Calculation Title: Appendix E – PMP Development Version Log	Calculation No.: CDQ0000002016000041	Rev. No.: 001	Sheet: E1
--	---	------------------	--------------

Calculation Title: Appendix K – Review Board Letter	Calculation No.: CDQ0000002016000041	Rev. No.: 001	Sheet: K3
--	---	------------------	--------------

Figure 13. Local Storm, SPAS 1209 (Wooster, OH) rainfall mass curve (left) and dew point analysis (right)

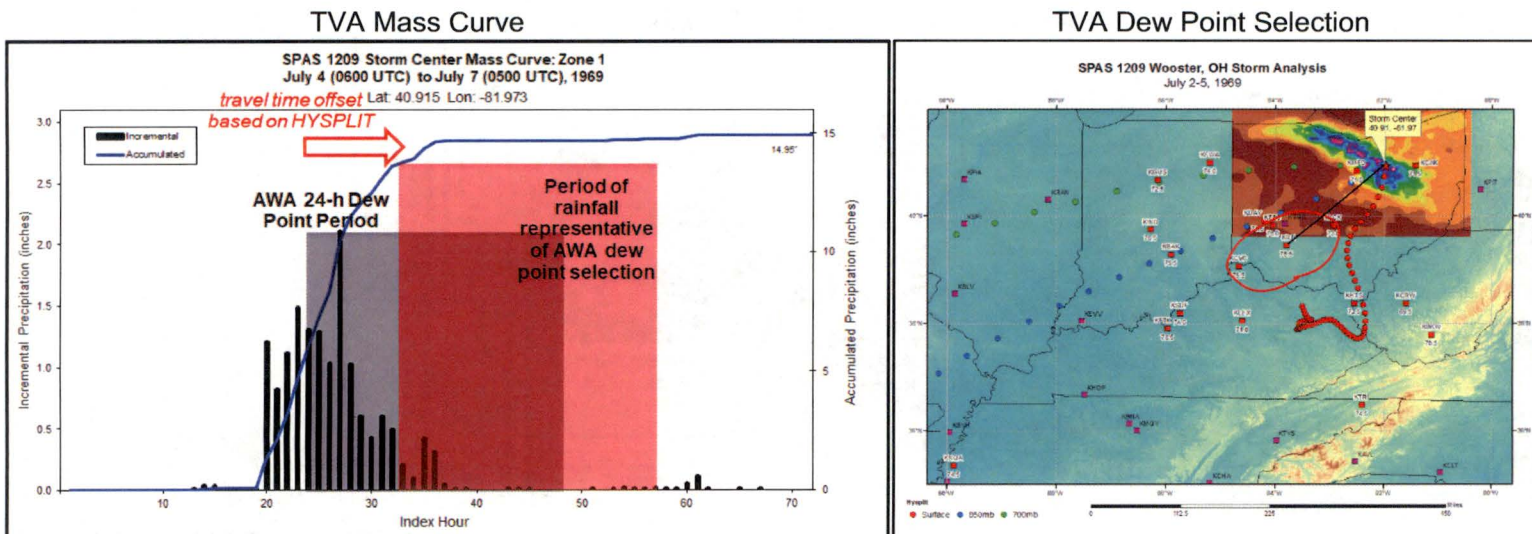
- b. Local Storm, SPAS 1226 (College Hill, OH) - Figure 12
 - c. Local Storm, SPAS 1209 (Wooster, OH) - Figure 13
 - d. Tropical Storm, SPAS 1182 (Larto Lake, LA) - Figure 14

TVA Figure 2. Smethport, PA and Simpson, KY adjusted rainfall plotted on the world record depth-duration curve

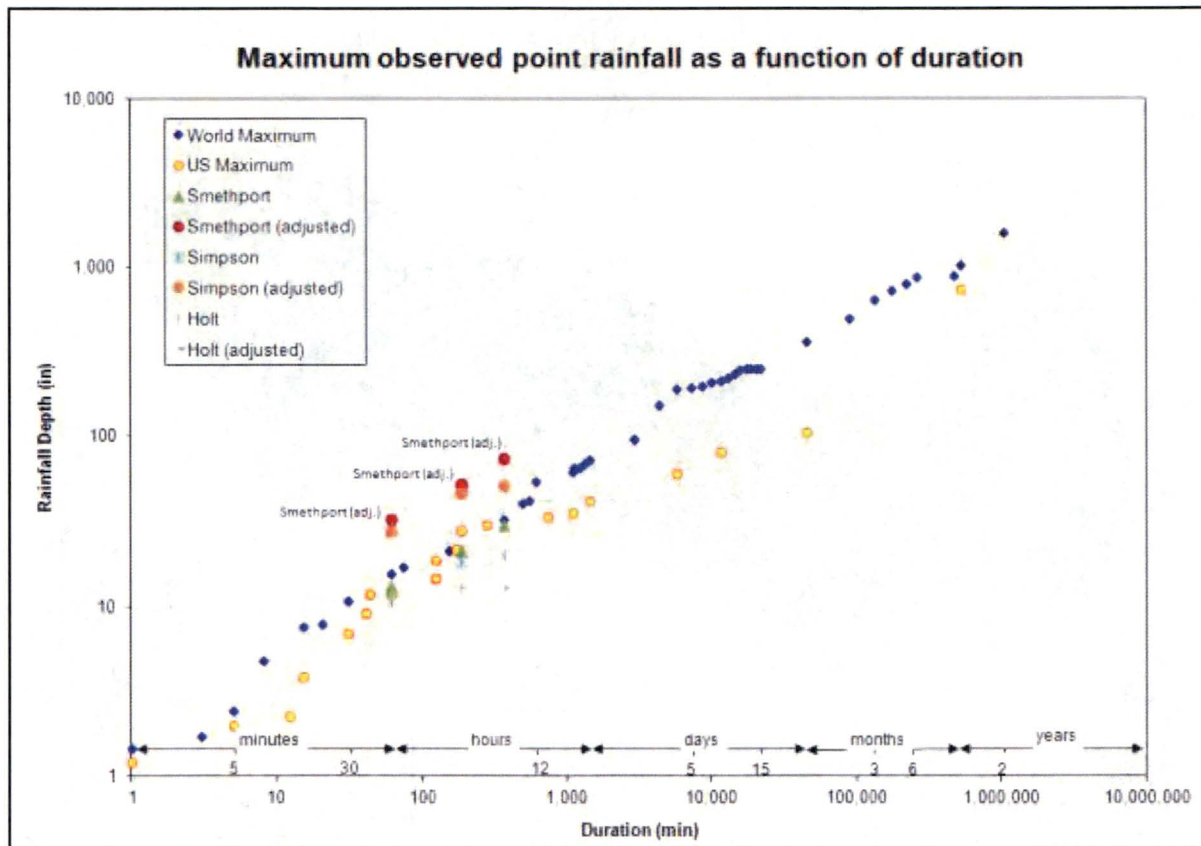
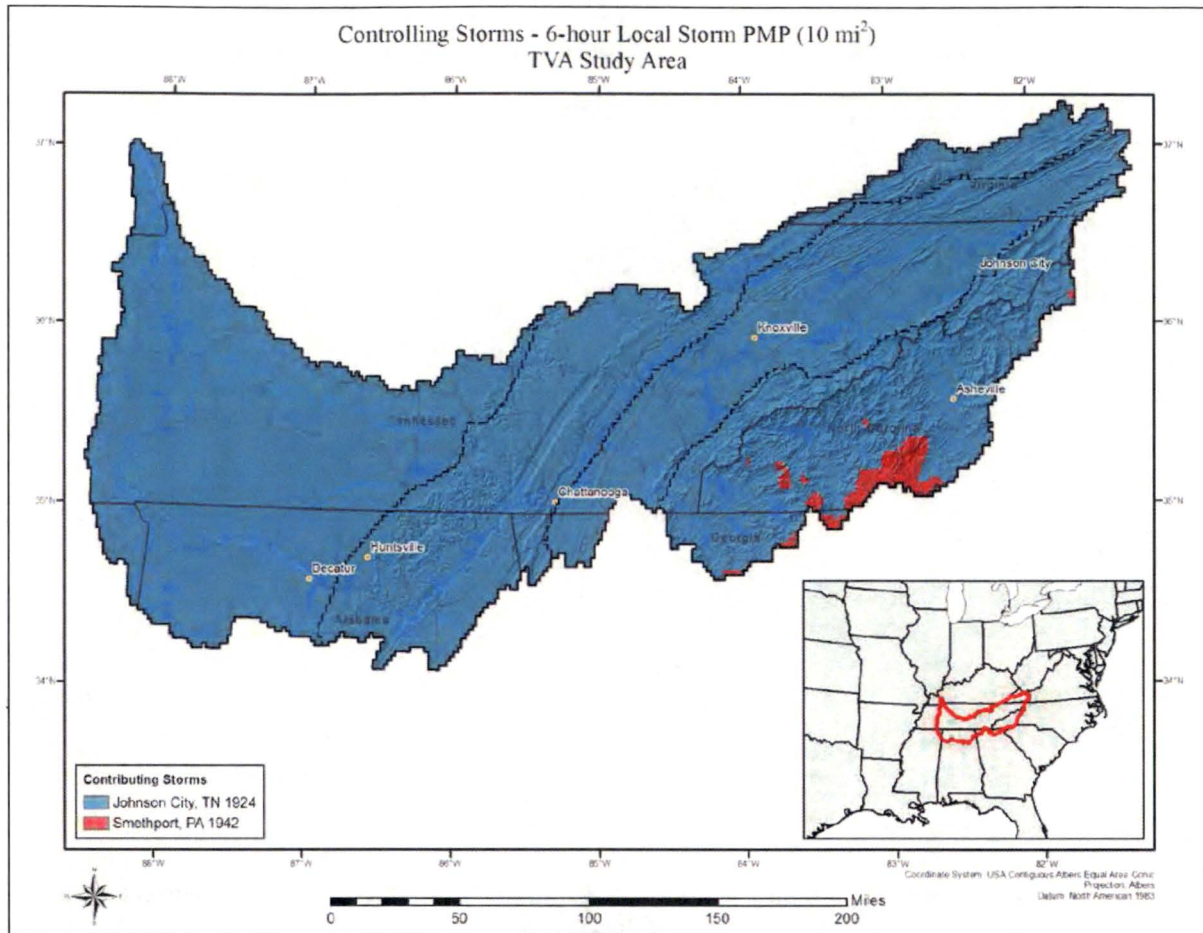
Although it is possible that the Smethport, PA storm is not transpositionable to any part of the TVA basin, no conclusive data existed to eliminate the storm. However, several data adjustments suggested this possibility. This included anomalously high OTF values and high MTF values. In these types of situations where there is no clear argument for inclusion or exclusion, the TVA choice is made to include the storm. In doing so, adjustment factors and fit with other adjusted storms must be considered, similar to the discussions in HMR 51 Section 3.2.2 and Section 3.2.4. Use of the storm and the storm adjustment values as calculated, resulted in unreasonably high rainfall depths when transposing the storm from north central Pennsylvania to the TVA basin. An MTF value greater than 1.00 results from the fact that the target grid locations in the TVA basin are closer to the moisture source region than the area associated with the storm center in north central Pennsylvania. More significantly, much of the target region has greater precipitation frequency depths due to more frequent extreme rainfalls and enhanced orographic influence. This results in calculated total adjustment factors at the target grid locations that are greatly inflated where the OTF values can exceed 2.00.

Generally, when OTF values are > 1.50 , the storm transposition limits are re-evaluated. This is because OTF values greater than 1.50 or less than 0.50 are an indication that the storm may not be transposable to that location since the physical characteristics may be too different from the source location. However, the storm must still be transposed to these locations. In these cases, the practice is to cap all OTF values at a maximum of 1.50. The Smethport event was a world record at its critical durations. Increasing rainfall by an areal-average MTF of 1.12 and applying an OTF in the traditional manner (much of the target cells would be capped at 1.50) would result in an adjusted rainfall over TVA transposition zone 4 that was much too high and not physically possible. In addition, the 1.50 OTF cap would result in constant spatial fields of PMP depth because almost the entire region is greater than the 1.50 OTF. TVA Figure 2 illustrates the adjusted rainfall depths in relation to the world record rainfall depth-duration curve. In summary, typical application of the OTF and MTF to the Smethport, PA storm over transposition zone 4 created unreasonably high rainfall depths without an appropriate spatial distribution. The Simpson, KY storm transposition resulted in a similar problem, although not to the magnitude of Smethport.

However, after further review and discussion with the NRC staff in regard to this question, TVA has agreed to add further conservatism and revise the OTF determination methodology used in LIP calculations. This methodology change ensures the OTF used in transpositioning local storms to the SQN, BFN and WBN plant sites is not less than 1.0. Note, this change only affects the Simpson, KY storm because the Smethport, PA storm was not transpositioned to the plant sites. Updates to this data set will affect Sections 6.1.1.5 and 6.4.4 of Calculation No. CDQ0000002016000041 and will be submitted as Revision 1 to Topical Report TVA-NPG-AWA16 (TVA Calculation CDQ0000002016000041).

TVA Figure 14. 24-hour 100-year precipitation illustrating discontinuity between volumes for 35° N

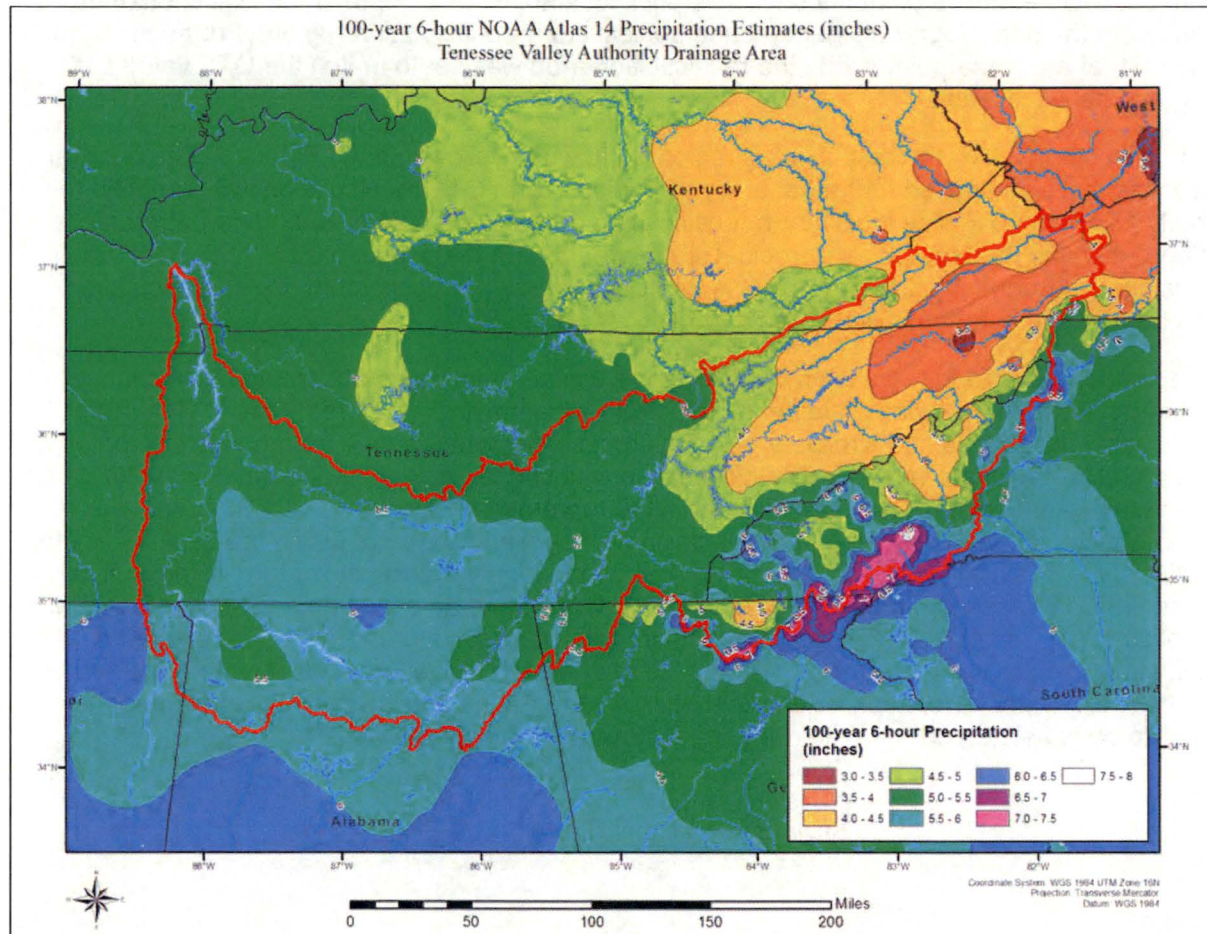
NRC Figure 6: Grid cells (in red) for which OTF differs between RAI #1 & RAI #3 for Local storms

Local storm PMP utilizes the 6-hour Atlas 14 precipitation frequency grids for OTF calculations. At the 6-hour duration, the boundary issue exists along the 35° N state boundaries similarly to the 24-hour duration. Furthermore, there is also a significant discontinuity over the Tennessee/North Carolina/Central Georgia state border. The depth of rainfall over the Hiwassee River drainage basin south of 35°N (Atlas 14 Volume 9) is significantly less than north of 35°N (Volume 2), as shown in TVA Figure 15.

In addition, the area in red shown in NRC Figure 6 was reevaluated due to the significant disparity between the Atlas 14 volumes over the Hiwassee drainage area. The OTF for this area was recalculated in a similar way to the process described above for the western region of the project area where a representative location was chosen and each grid point within the area of interest (AOI) was assigned the OTF from the representative location. For this area, the absolute cell reference representative location was chosen as a point within the basin near the outlet of the basin at 35.15° N, -84.45° W. Due to the highly orographic nature of the AOI, a constant OTF reassignment alone is not sufficient; therefore an elevation adjustment factor was applied to the constant OTF to estimate the orographic effect over the AOI. The elevation adjustment factor was determined as the ratio of elevation at the target location to the elevation at the representative location, which is 1,624'. A sixth root is applied to sufficiently mute the ratio to be consistent with the surrounding OTF values outside the AOI.

TVA Figure 16. Example of general storm PMP before constant OTF adjustment

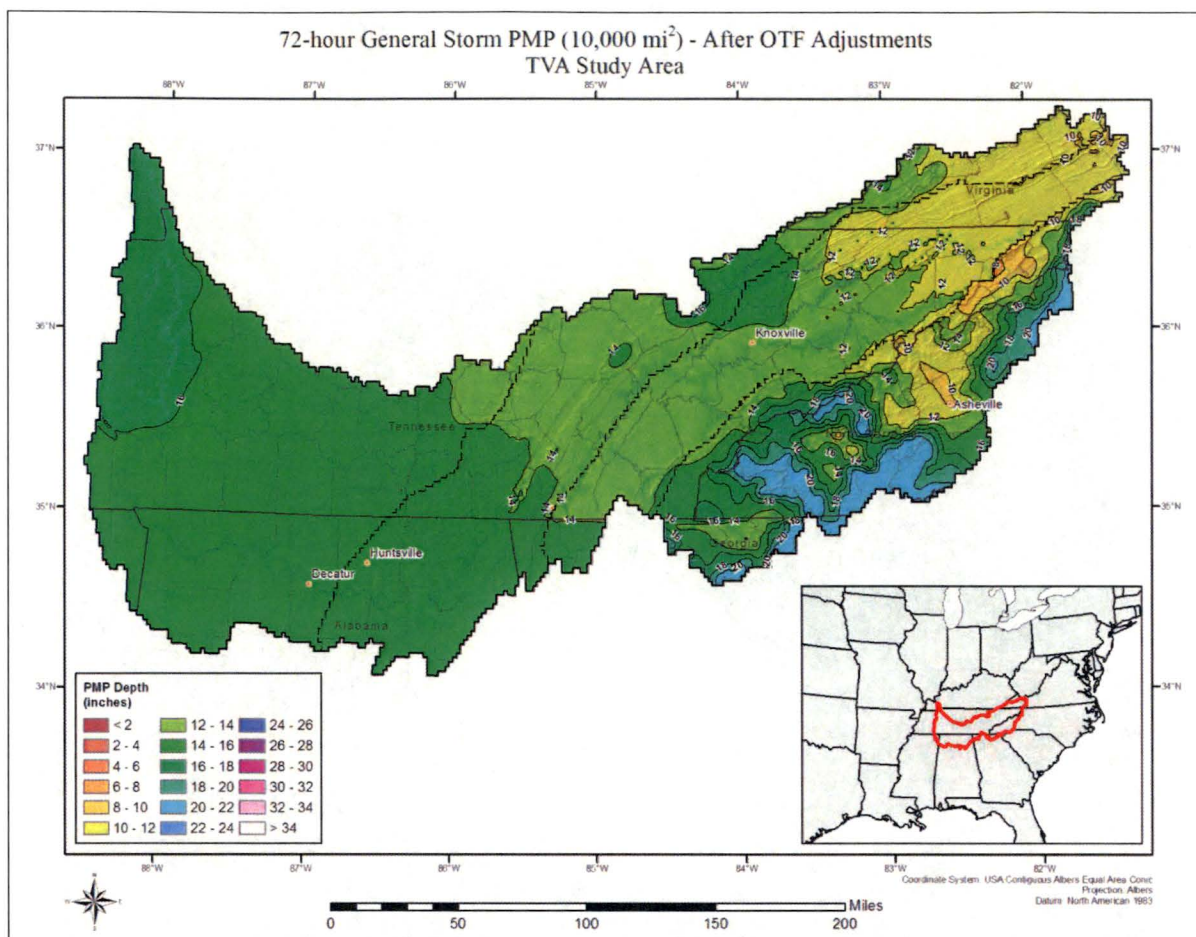
An example map of general storm PMP before the constant OTF adjustments over the western portion of the project area is provided in TVA Figure 16. TVA Figure 17 shows the same PMP map after the general/tropical storm OTF adjustments are implemented.

TVA Figure 18. Example of local storm PMP before constant and elevation-dependent OTF adjustments

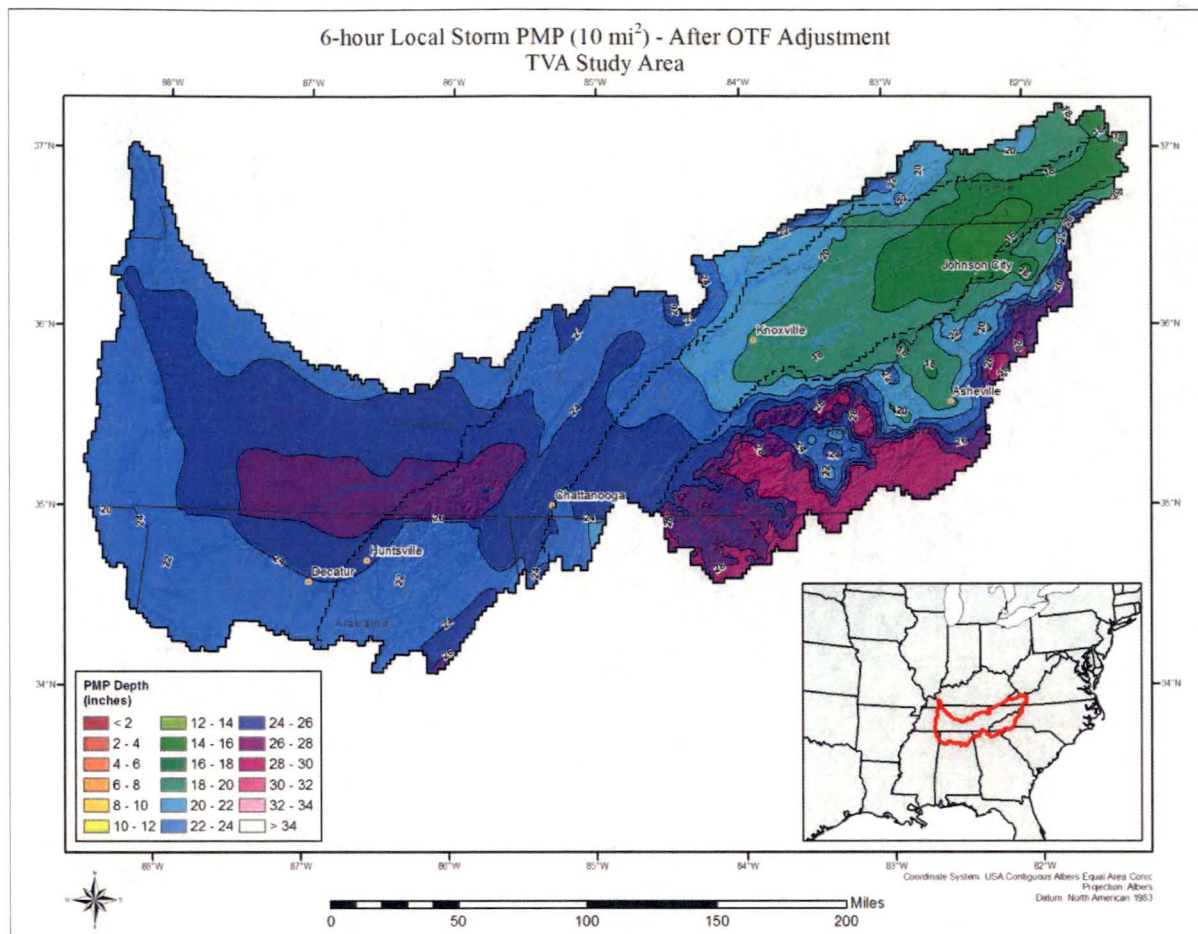
An example map of local storm PMP before the constant OTF adjustments over the western portion of the project area and the elevation-based OTF adjustments over northern Georgia is provided in TVA Figure 18. TVA Figure 19 shows the same PMP map after the local storm OTF adjustments are implemented.

TVA Figure 30. TVA transposition map for the Larto Lake, LA September 2008 storm

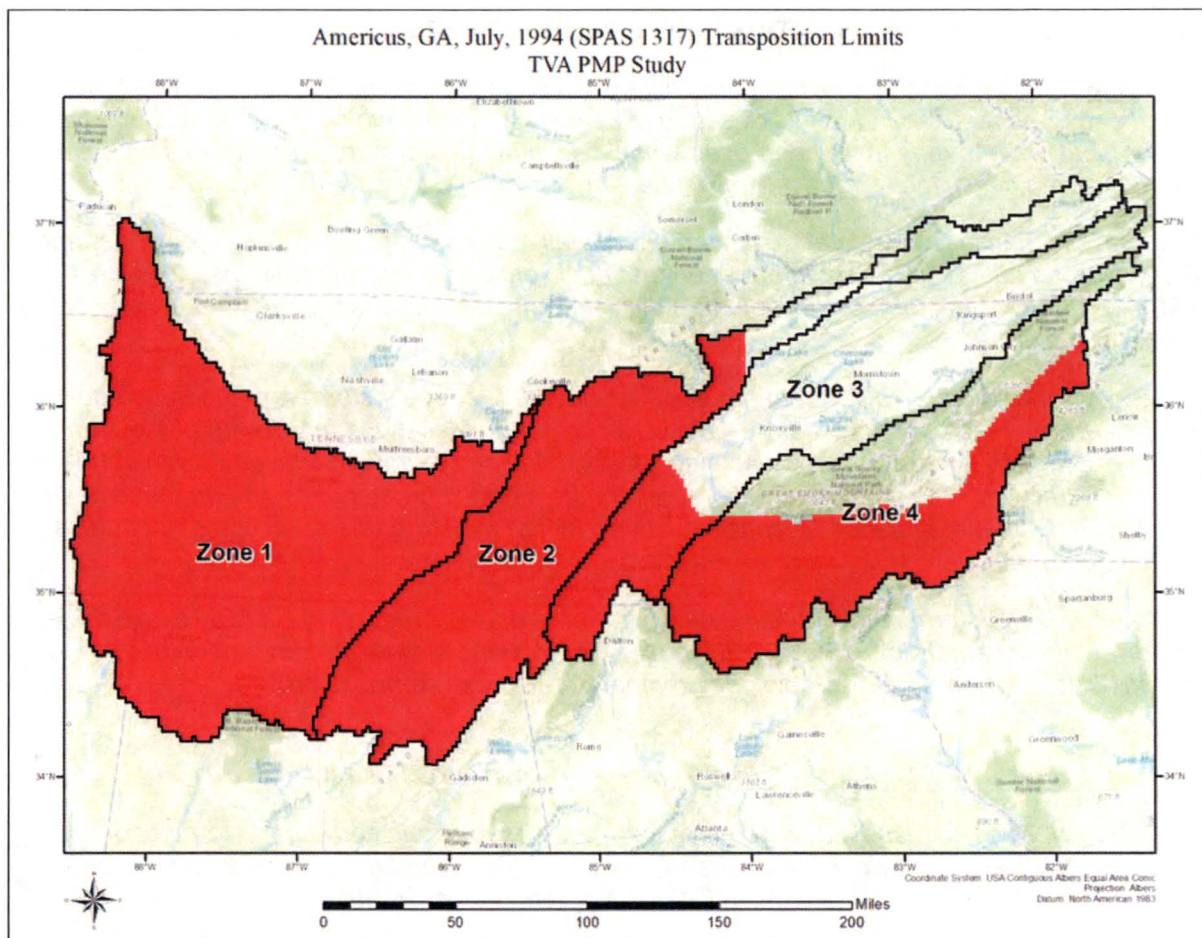
4. Tropical Storm, SPAS 1317 (Americus, GA) – see Figure 10
 - a. By adjusting the HYSPLIT backward trajectory timing to more closely align with the onset of rainfall, staff identified a moisture inflow direction of SE-to-S rather than WSW.

TVA Figures 24-29 display the transposition limits applied to storms by the NWS, which occurred in similar regions as Larto Lake, LA and Americus, GA events. Each of these figures clearly demonstrates that the NWS did not consider storms in these regions transpositionable to the Tennessee Valley and specifically to the interior regions of the Tennessee River basin. In fact, the custom limits applied by TVA (TVA Figures 30 and 31) are significantly more conservative than the NWS transposition limits. TVA allowed these storms to affect the southern portions of the TVA region to ensure appropriate spatial continuity in PMP values between these regions and to account for the uncertainty of where the exact boundary would occur. However, the rainfall that occurred with the storms would not occur in the same meteorological and topographical setting existing over the interior TVA regions. Note, this does not mean that remnant tropical moisture doesn't produce rainfall in that region. Instead the magnitude of those rainfall events is significantly reduced because of the different interactions of topography and meteorology, thereby violating the definition of transpositionability. This requires that remnant tropical storms that occurred in similar meteorological and topographical settings be used in that region. This excludes the Larto Lake, LA and Americus, GA storms from consideration.

NRC Figure 7. General Storm, SPAS 1206 (Big Rapids, MI) rainfall mass curve (top) and dew point analysis (bottom)

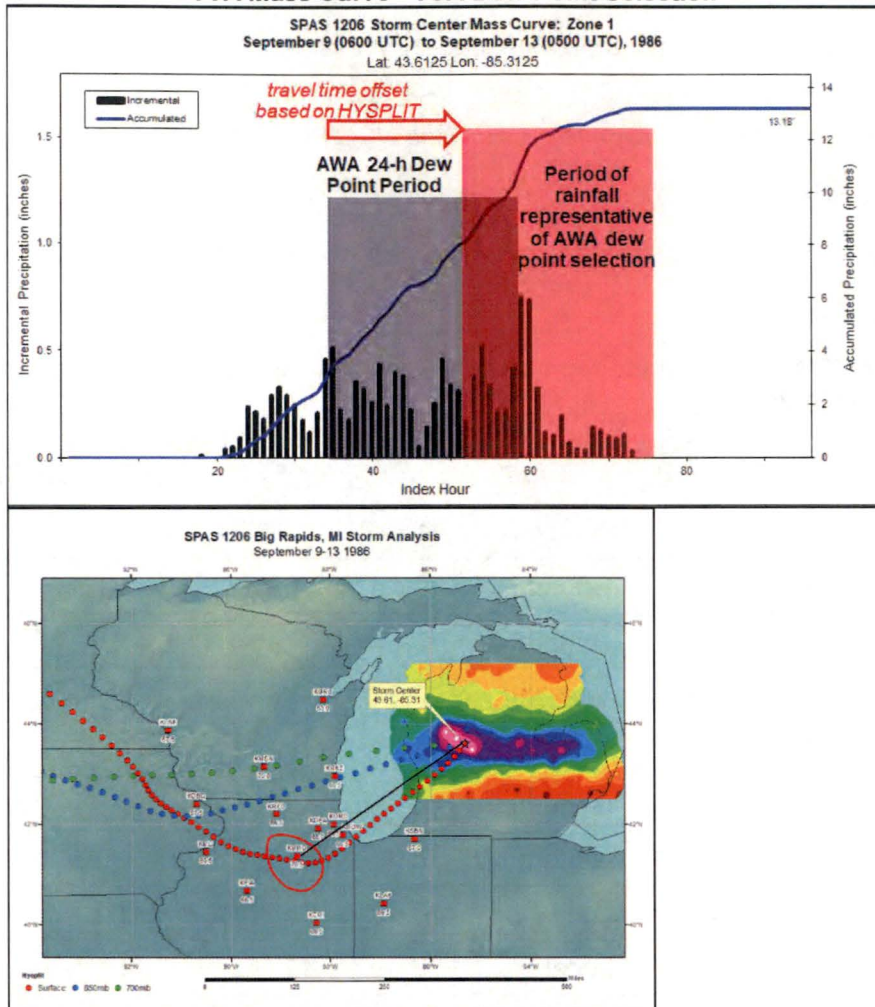
1. General Storm, SPAS 1206 (Big Rapids, MI) – see Figure 7
 - a. The licensee's dew point temperature observations correspond to a period after significant rainfall had already occurred. The representative dew point location is approximately 230 miles SW of the storm center location.

Request: Provide justification for the selection of storm representative dew point values for the above storms with respect to timeframe and location selected, especially considering the timeframe of when rainfall occurs at the storm center. If corrections are warranted, provide an updated analysis as it may affect TVA's 3 NPP sites.
